PL 21-2796

Tentative Parcel Map; Major Site Plan
Review for a 3-Unit Condominium
Development

9014 Pentland Street

Planning Commission Meeting

- Third Submittal-
front elevation

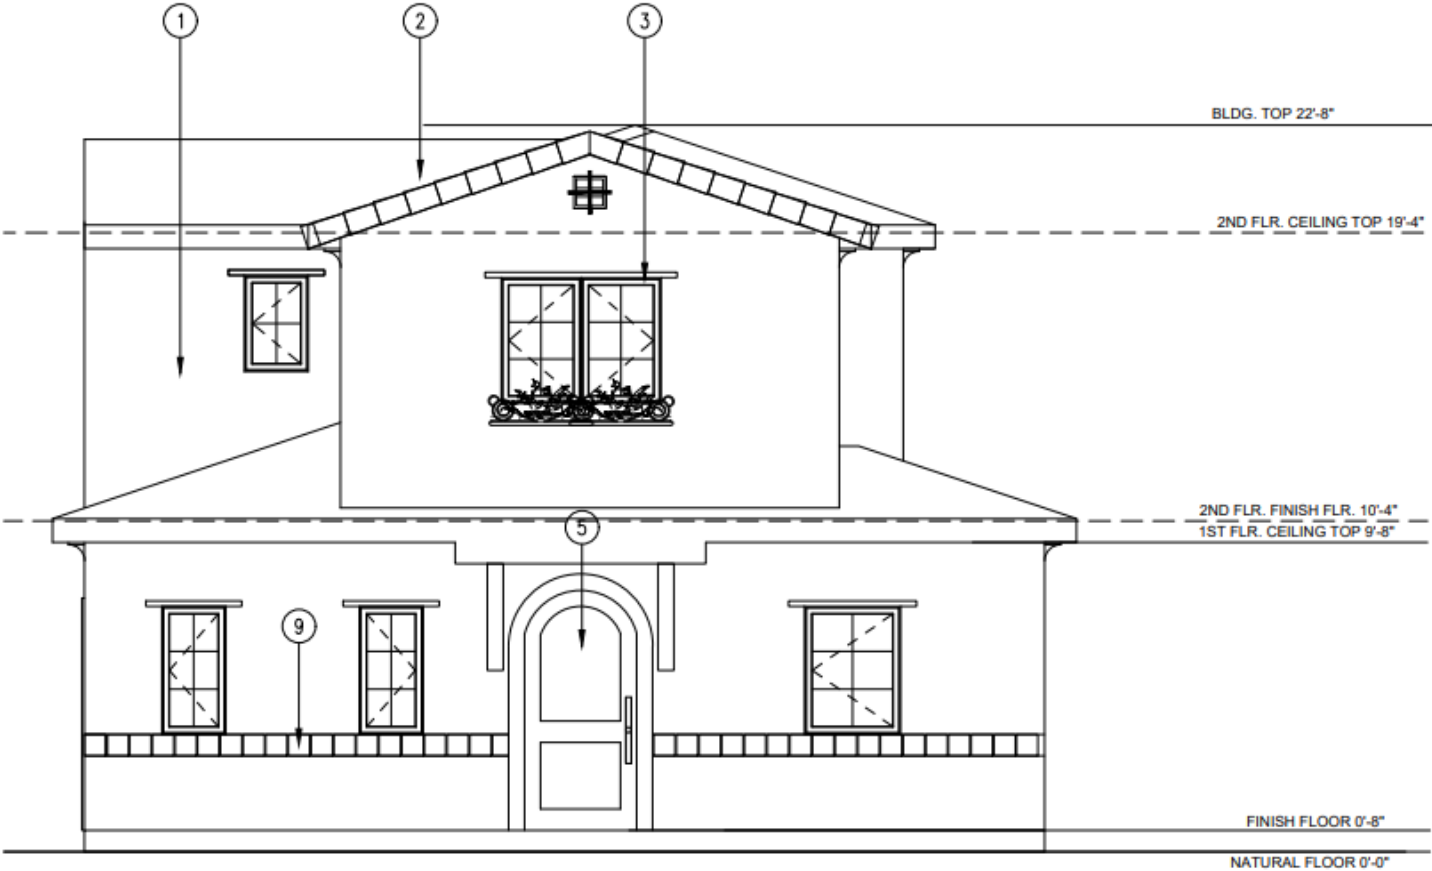
Condition 5: place tile on front elevation inside front entry alcove

WEST ELEVATION (DRIVEWAY SIDE)
SCALE: 3/16" = 1'-0"

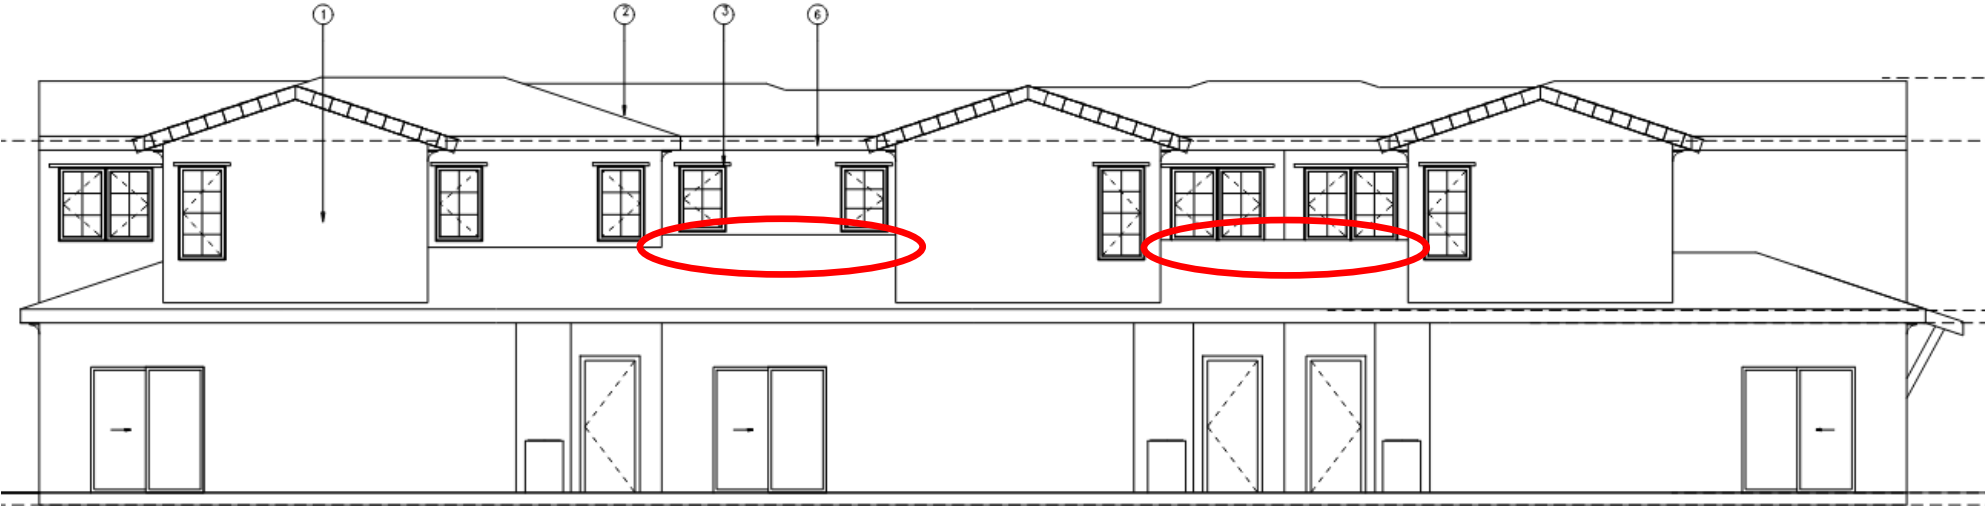
Condition 6: Rear unit front porches will utilize archways consistent with Unit 1.

Condition 7: Keep bottom window sill away from roof ridge.
